**SUBDIVISION,
PLANNED UNIT DEVELOPMENT, &
REZONING STAFF REPORT****Date: August 6, 2015**

<u>APPLICANT NAME</u>	Barton & Shumer Engineering, LLC
<u>SUBDIVISION NAME</u>	Russell Elementary Subdivision
<u>DEVELOPMENT NAME</u>	Russell Elementary Subdivision
<u>LOCATION</u>	304 South Broad Street and 903 Augusta Street (Southwest corner of South Broad Street and Augusta Street)
<u>CITY COUNCIL DISTRICT</u>	Council District 2
<u>PRESENT ZONING</u>	R-1, Single-Family Residential District
<u>PROPOSED ZONING</u>	R-3, Multiple-Family Residential District
<u>AREA OF PROPERTY</u>	1 Lots/1.2± Acres
<u>CONTEMPLATED USE</u>	<p>Subdivision Approval to create a single legal lot of record from six legal lots of record and a single metes and bounds parcel; Planned Unit Development to allow multiple buildings on a single building site, and Rezoning from R-1, Single-Family Residential District to R-3, Multiple-Family Residential District to allow an apartment complex.</p> <p>It should be noted, however, that any use permitted in the proposed district would be allowed at this location if the zoning is changed. Furthermore, the Planning Commission may consider zoning classifications other than that so

PROP SITE PLAN

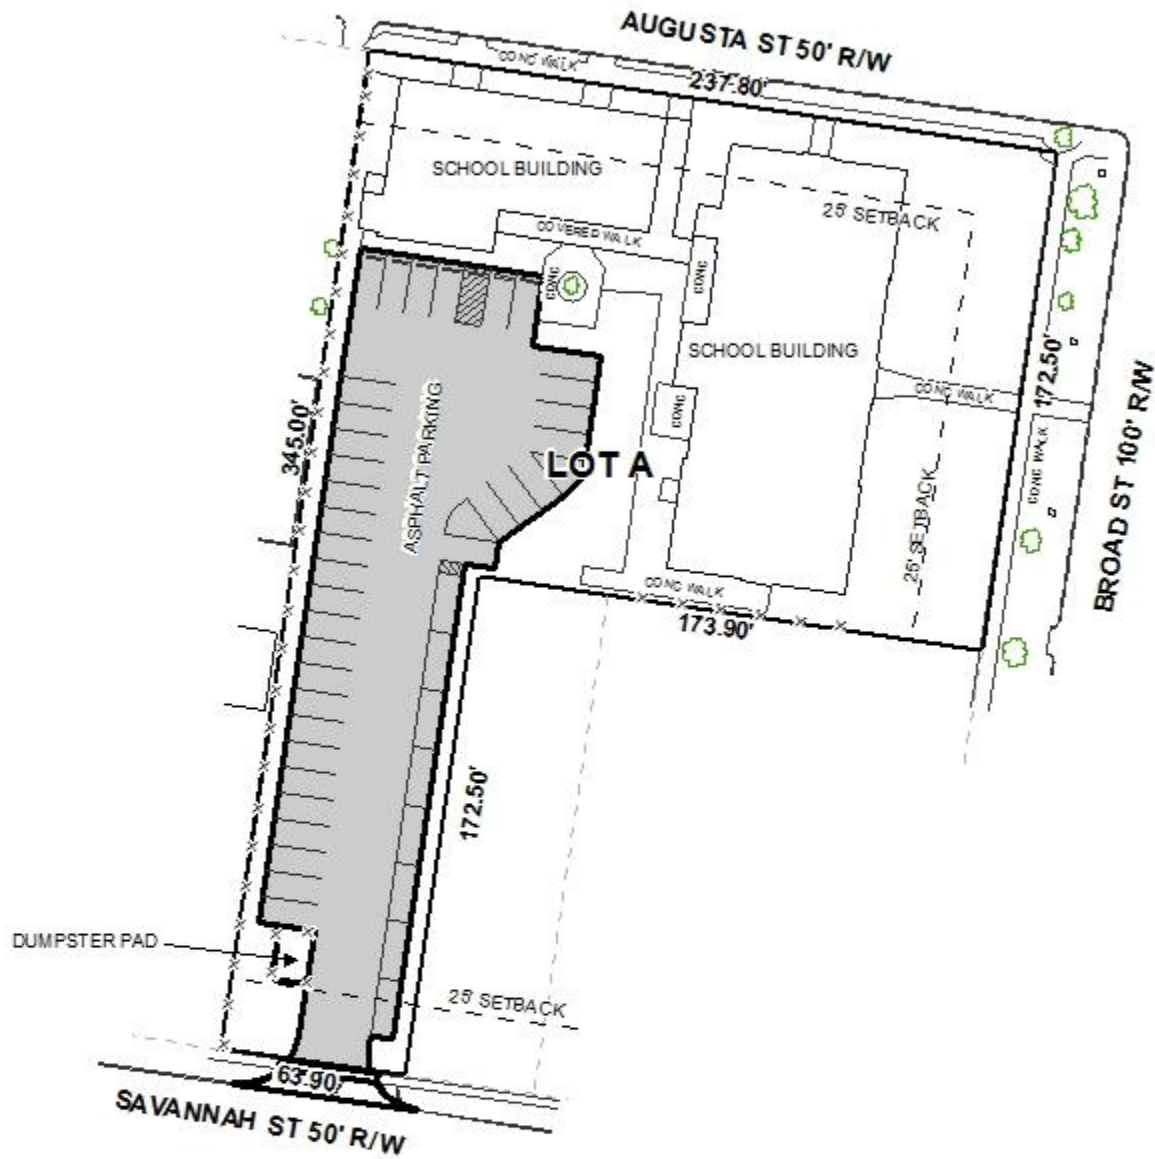
Based on the proposed density for this site, a traffic impact study will not be required. Site is limited to one curb cut to Savannah Street, with size, location and design to be approved by Traffic Engineering and conform to AASHTO standards. Any new on-site parking, including ADA handicap spaces, shall meet the minimum standards as defined in Section 64-6 of the City's Zoning Ordinance. The parallel parking spaces should be increased to 23', since all but the furthest north space is encumbered. The northern most parallel space can be 20' in length. The parking count may reduce by one space, but the site will still provide the required parking count, as noted on the plan.

The site plan submitted illustrates two existing buildings which are proposed to consist of 28 dwelling units. The site plan illustrates 43 parking spaces, which exceeds the minimum requirement of 42 parking spaces, however, per Traffic Engineering comments, the parallel parking spaces should be revised to be 23' long, with the exception of the Northern most parallel space, which will result in the loss of one parking space, but will still meet the minimum required number of parking spaces for the development.

A dumpster is illustrated on the site plan with an enclosure, but no mention is made of the type of enclosure, or if it will be connected to sanitary sewer. If approved, the site plan should be revised to state that the dumpster will be connected to sanitary sewer and have an enclosure compliant with Section 64-4.D.9. of the Zoning Ordinance.

The site plan submitted illustrates a 6' high wooden privacy fence (reduced to 3' high within the 25' building setback) next to most of the adjacent R-1, Single-Family Residential District, and a 3' high hedge or wood fence proposed to screen the proposed parking areas from residences across Savannah Street. The site plan should be revised to illustrate a wooden privacy fence next to all adjacent R-1, Single-Family Residential District properties.

- 1) revision of the site plan to depict dedication of the corner radii at South Broad Street and Augusta Street per Section V.D.6. of the Subdivision Regulations;

- 2) revision of the site plan to illustrate the canopies associated with the existing trees in the right-of-way;
- 3) coordination of tree plantings for the site with Planning Division staff, with the understanding that tree banking may be required;
